PRODUCT / PROCESS CHANGE NOTIFICATION

1.1 Company	 STMicroelectronics International N.V
1.2 PCN No.	EMBEDDED PROCESSING/26/16389
1.3 Title of PCN	ST Shenzhen (china) additional source for STM32F2x and STM32F4x listed products in LQFP 14x14 packages
1.4 Product Category	STM32F205x, STM32F207x, STM32F215x, STM32F217x, STM32F405x, STM32F407x, STM32F415x, STM32F417x, STM32F427x, STM32F429x, STM32F437x and STM32F439x
1.5 Issue date	2026-06-30

PCN16389 – Additional information

ST Shenzhen (China) additional source for STM32F2x and STM32F4x listed products in LQFP 14x14 packages.

Standard marking fields example for **LQFP 100 14x14** package

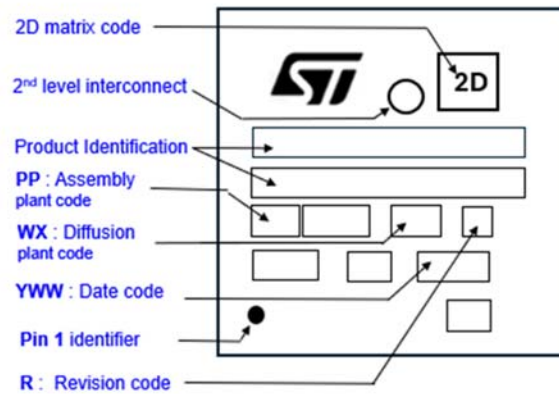
Pin1 identifier may change in terms of size and positioning however remaining near pin1's edge.

Marking position and size may be different upon assembly site, without any loss of information.

Table 3: Package top view marking example with STM32F205VET6 Commercial product

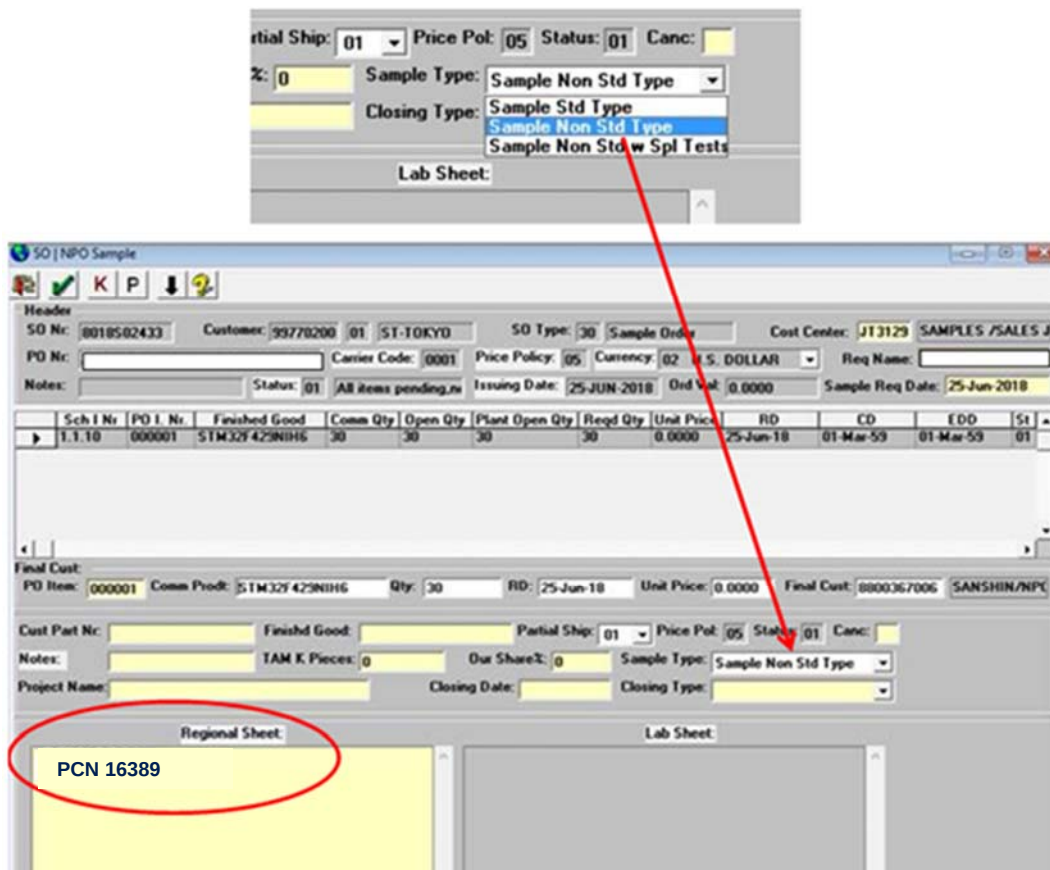
Back-End Assembly sites	Existing Back-end	Added Back-End Site
Assembly plant code PP	AA: ASE KaoHsiung (Taiwan) 99: ST Muar (Malaysia) 7B: AMKOR ATP (Philippines)	GK: ST Shenzhen (China)
